Access Compliance Report

Public Rights-of-Way

(Curb Ramps)

Intersection ID: 14383	Main Street: CLEVELAND_AV	Cross Street: E TREMONT AV	Location: W
ADA ID: 09C29D0EE5CF	Ramp Type: PerpDiag	Initial Pass/Fail: Fail	Overall Compliance: No
		Severity Score: 12.5

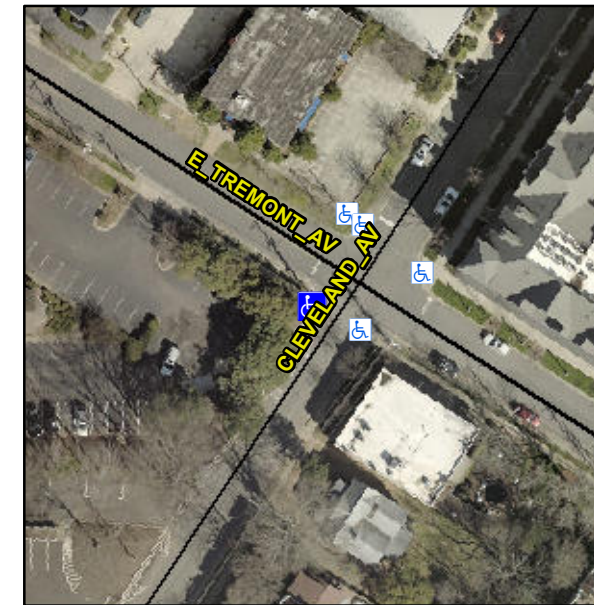
Not Found, R304.2.2

Compliance	Description	Data	Compliance	Description	Data
N/A	Ramp Length (in)	52.0	No	Ramp Slope (%)	10.1
Yes	Ramp Width (in)	48.0	Yes	Ramp XSlope (%)	1.9
N/A	Flare Type LT	N/A	N/A	Flare Type RT	N/A
N/A	Flare Slope LT (%)	N/A	N/A	Flare Slope RT (%)	N/A
N/A	Flare Traversable LT?	N/A	N/A	Flare Traversable RT?	N/A
N/A	Landing Length (in)	N/A	N/A	DWS Provided?	N/A
N/A	Landing Width (in)	N/A	N/A	DWS Contrast?	N/A
N/A	Landing Slope (%)	N/A	N/A	DWS Length (in)	N/A
N/A	Landing X Slope (%)	N/A	N/A	DWS Full Width?	N/A
N/A	Landing Curb? (Y/N)	N/A	N/A	DWS Offset (in)	N/A
N/A	Shared Landing?	N/A			
N/A	Gutter Ponding?	N/A	N/A	Gutter Slope (%)	N/A
N/A	Gutter Lip Ht (in)	1.0	N/A	Gutter X Slope (%)	N/A
N/A	Painted X Walk1?	No	N/A	Painted X Walk2?	No
	X Walk 1 Direction	To SE		X Walk 2 Direction	To NE
N/A	X Walk 1 Width (in)	N/A	N/A	X Walk 2 Width (in)	N/A
	X Walk 1 Slope (%)	1.0		X Walk 2 Slope (%)	0.2
	X Walk 1 X Slope (%)	3.3		X Walk 2 X Slope (%)	1.2

Remove & Replace Curb Ramp With Two New Directional Ramps or Equivalent.
